DEVELOPMENT REVIEW COMMITTEE

CASE COMMENT REPORT

CASE NO. UDP-S25001

CASE	UDP-S25001
PROJECT NAME	Harbor Beach Residents
APPLICATION TYPE	Site Plan Level III
APPROVAL LEVEL	Planning and Zoning Board, Subject to Commission Request for Review
REQUEST	Conditional Use for Building Height above 150 Feet, Waterway Use, and Yard Modification Request for 36-unit Multifamily Development
APPLICANT	One on One Harbor Beach, Inc.
AGENT	Jason Crush, Crush Law, P.A.
PROPERTY ADDRESS	3043 Harbor Drive
ABBREVIATED LEGAL DESCRIPTION	Ocean Harbor 26-39 B Lot 6
ZONING DISTRICT	Residential Multifamily High Rise/High Density (RMH-60)
LAND USE	High Residential
COMMISSION DISTRICT	4- Ben Sorensen
NEIGHBORHOOD ASSOCIATION	Harbor Drive Association
SUBMITTED	January 24, 2025
COMPLETENESS ISSUED	January 29, 2025
APPROVAL/DENIAL TIMEFRAME	July 28, 2025 (180 Days)
WAIVER	Not Requested
CASE PLANNER	Adam Schnell Urban Planner III

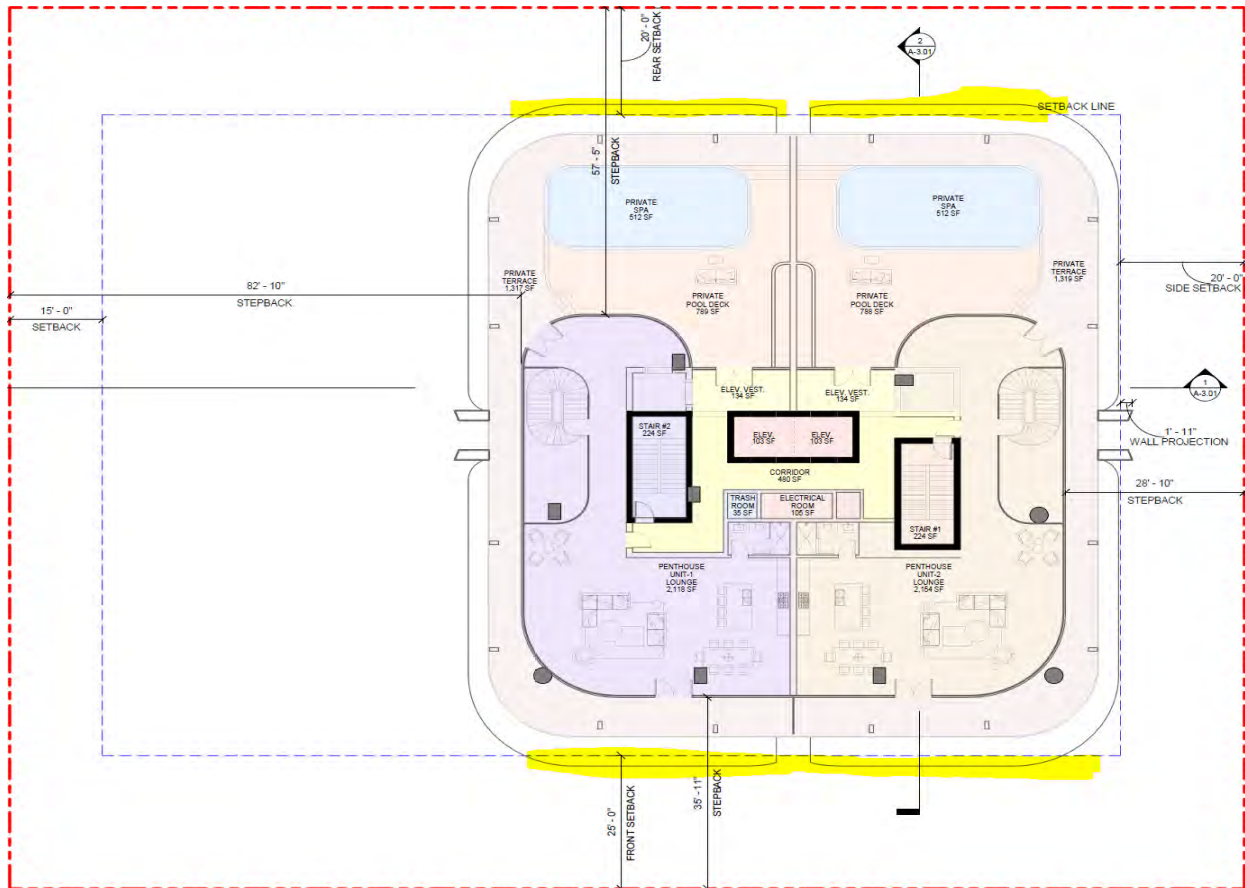
1. The surplus 19 proposed compact parking spaces shall be permitted but shall not count towards the minimum 79 parking space requirement.
2. For handicapped parking stalls, pursuant to Florida Statute 553.5041, each parking space must be at least 12 feet wide. Parking access aisles must be at least 5 feet wide and must be part of an accessible route to the building or facility entrance. The access aisle must be striped diagonally to designate it as a no-parking zone. Handicap Parking spaces shall be level, no more than a 2% slope. Handicap people shall not be directed to travel behind parked vehicles to access the building. Adjust the proposed Handicap parking to meet the criteria listed above.

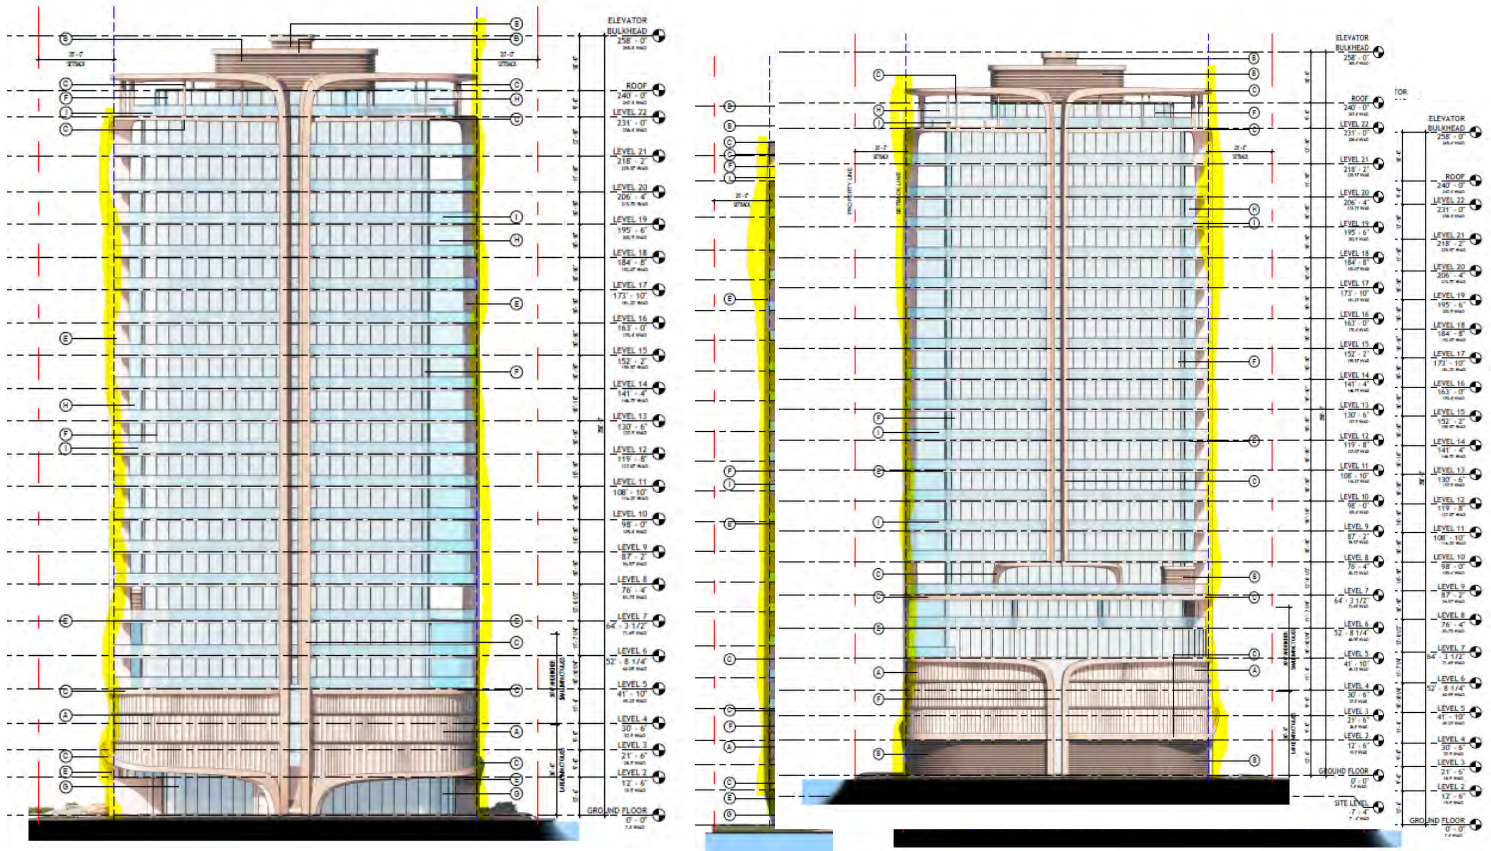
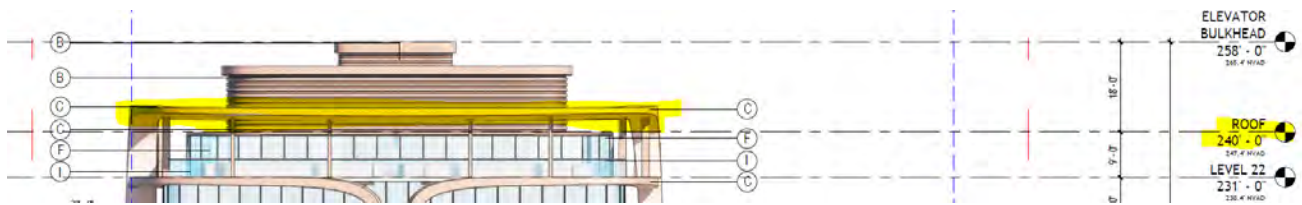
- 10) Provide the following changes on elevations:
- a. Canopy encroachment on Sheet A-0.09 does not match Sheet A-0.10 or Sheet A-1.00.
 - b. Provide measurements for architectural encroachment on all building elevations and site plan. Encroachment that exceeds 5-feet on the frontage or 3-feet on side yards or rear yard shall be

requested under the yard modification or removed. Reference images below for examples of encroachments that require measurements.
